RE: **Lot 5, Block 3 Volcano Cliffs Unit 22**  
**6320 Camino Alto Rd NW (S.A.D. 228)**  
**Grading and Drainage Plan**  
**Engineer's Stamp Date 6-10-16 (D10D003P8)**

Based upon the information provided in your submittal received 12/27/16, this plan is approved for Grading Permit.

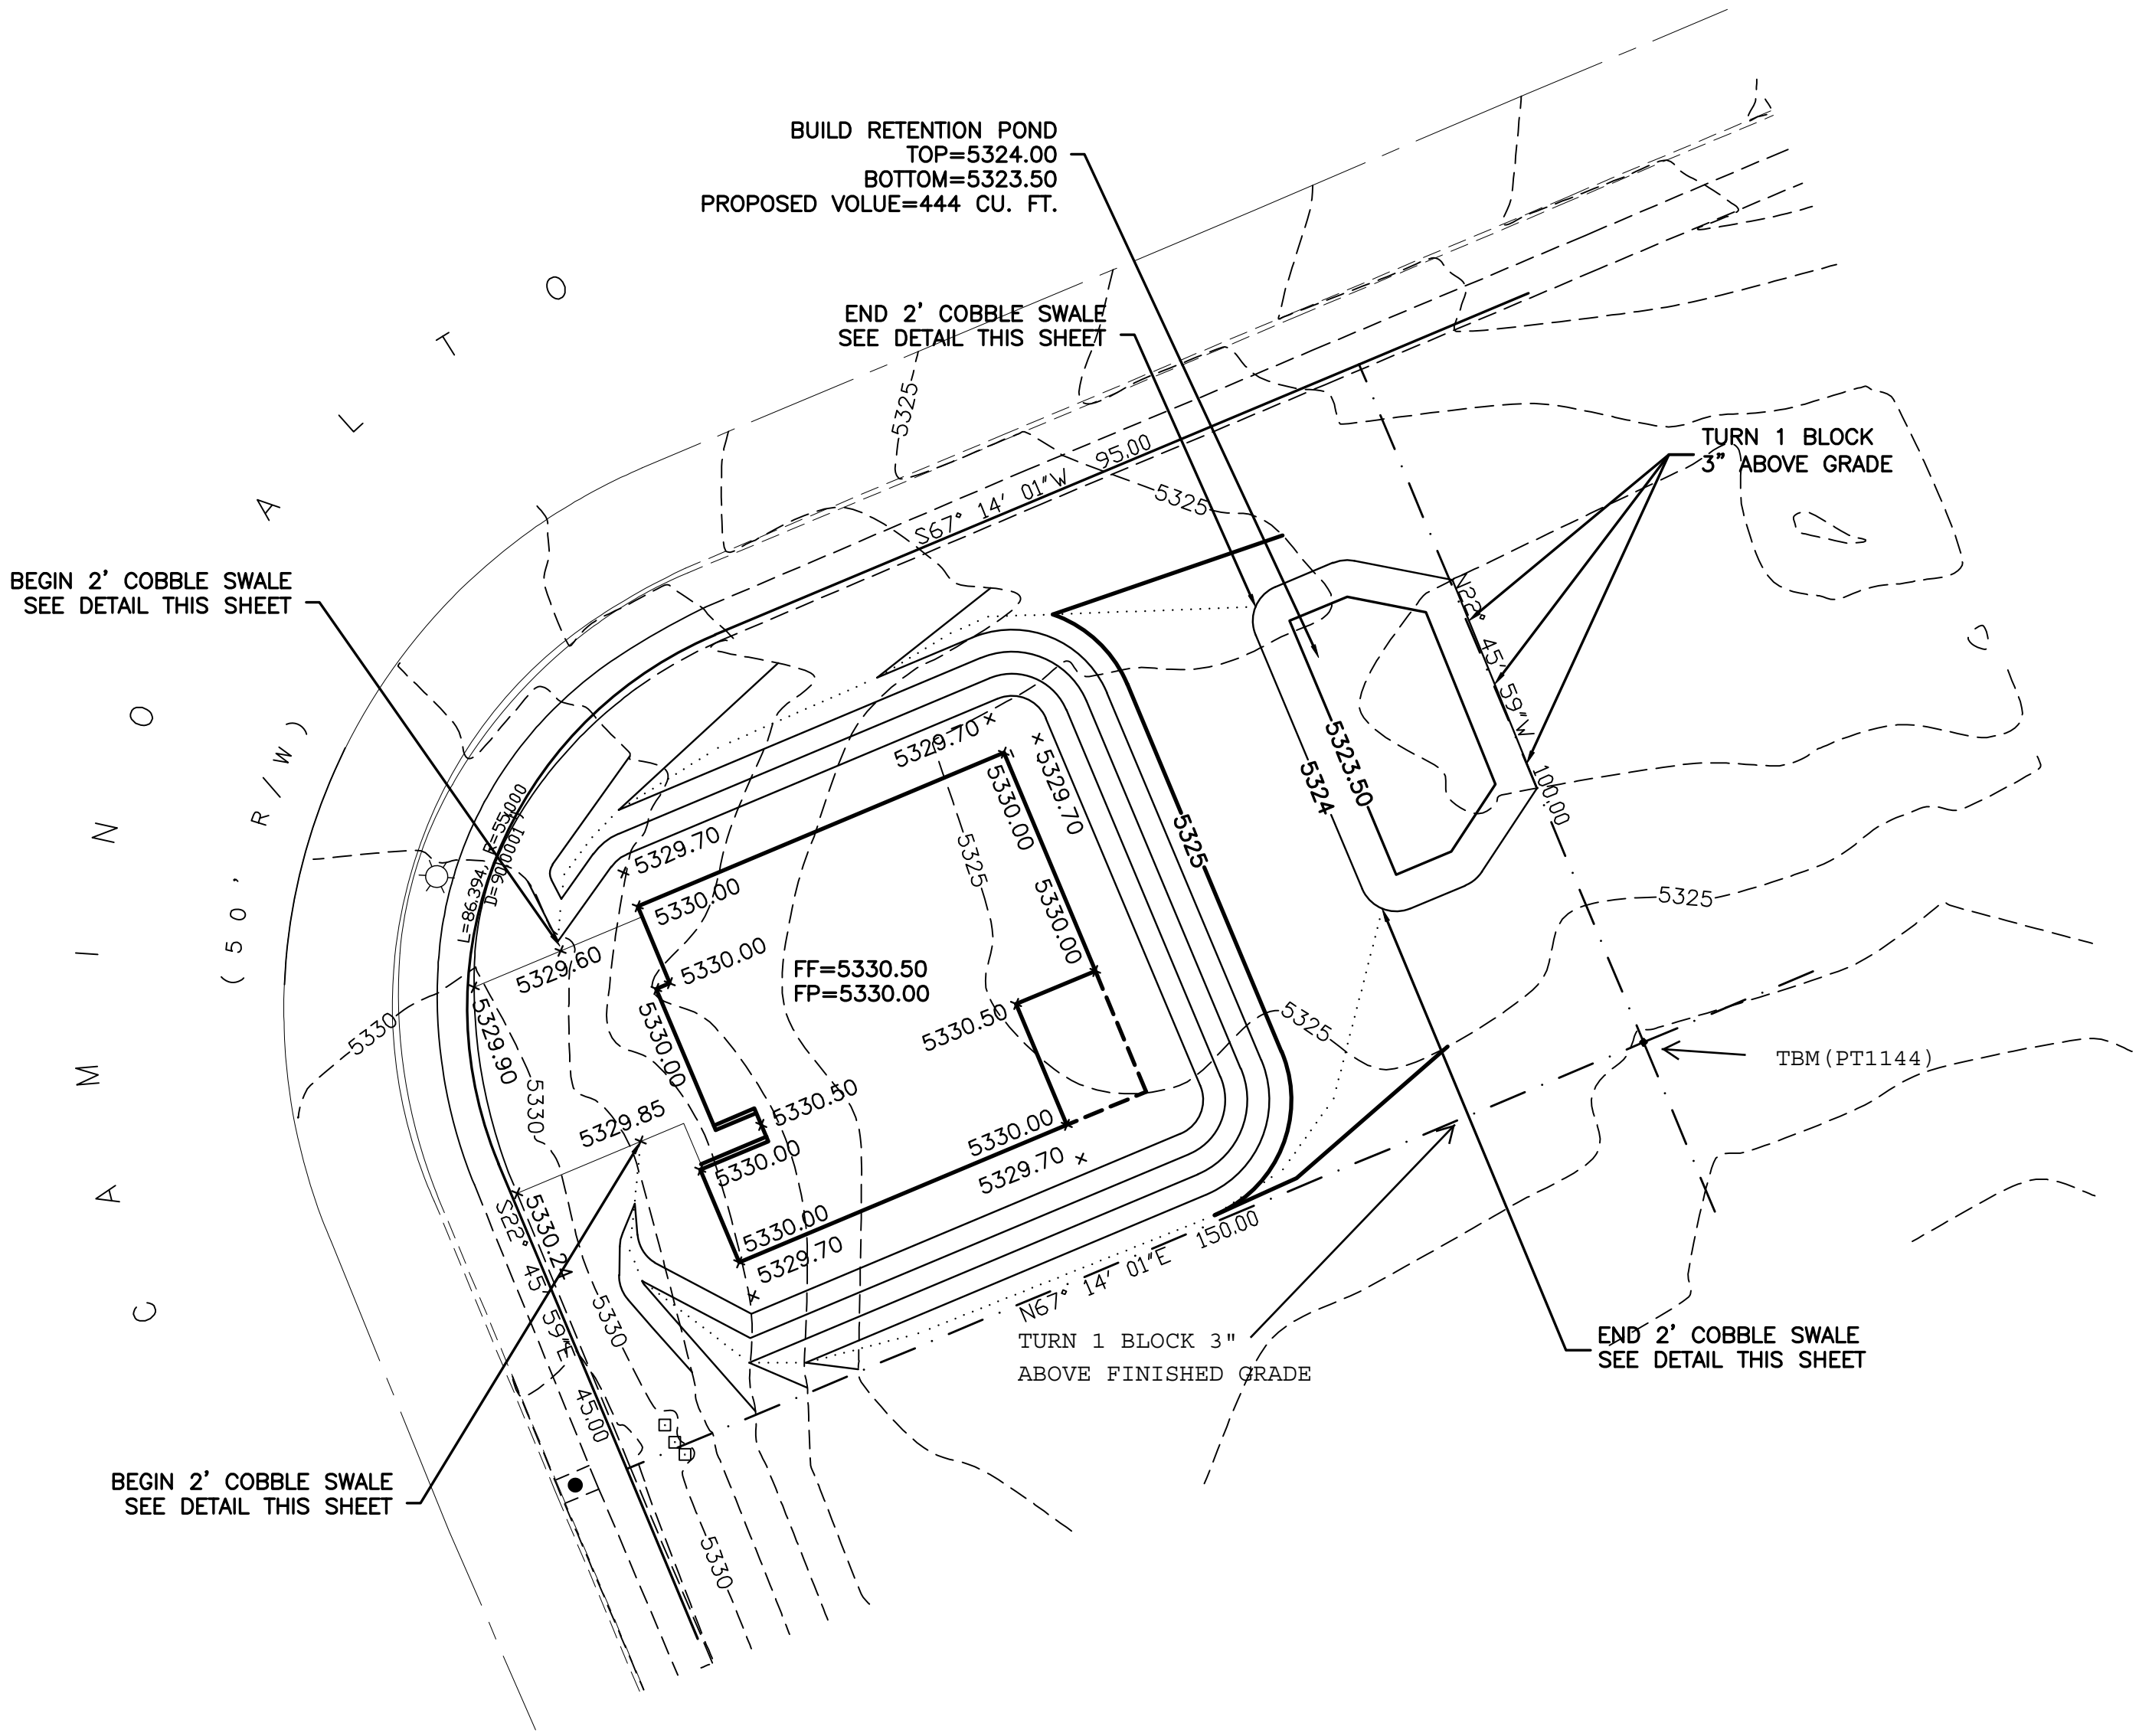
Prior to building Permit approval a Pad certification must be received, either by a written statement from the engineer of record or an as-built plan with spot elevations and signed by an engineer.

Please attach a copy of this approved plan to the construction sets in the permitting process prior to sign-off by Hydrology. A separate permit for the wall is required. Attach this approved plan to the wall permit set.

Prior to Certificate of Occupancy release, Engineer Certification per the DPM checklist will be required.
